Lloyd's Register of Shipping. F. 197 (SNG.)Ship's Name "M. V. CRISTA"Official No. 166611.

Memorandum of alterations reported since ship was surveyed for assignment of Load Lines in _____

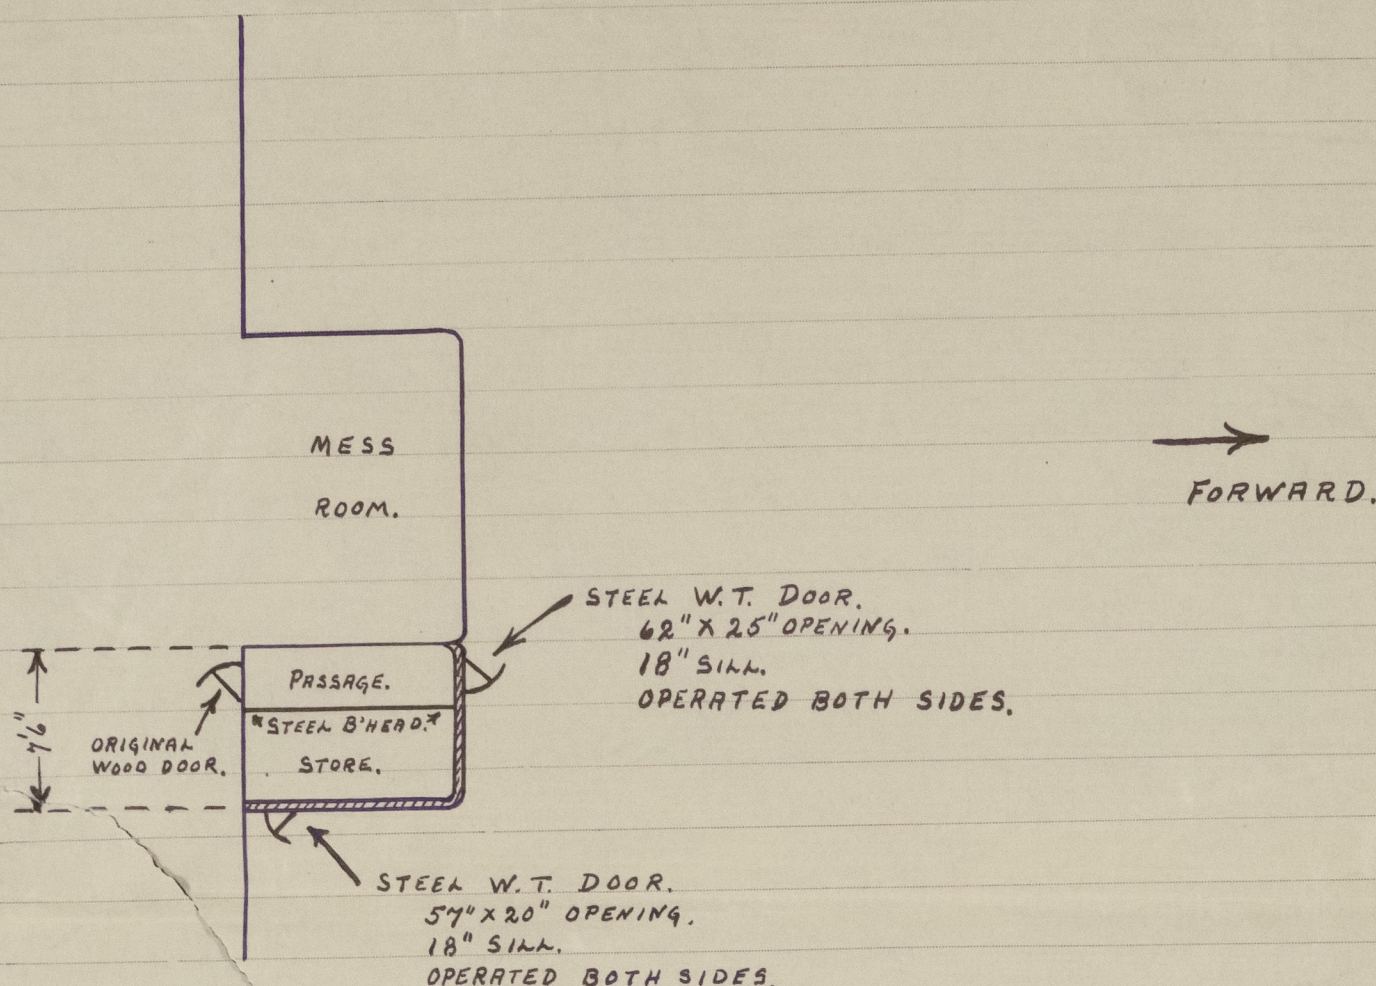
The poop front bulkhead has been altered as indicated below:—

The addition is indicated in double lines with hatched lines. The new plating is $\frac{1}{20}$ " thicker than the original poop front plating, the additional stiffener in the store is of the same scantlings as other poop front stiffeners.
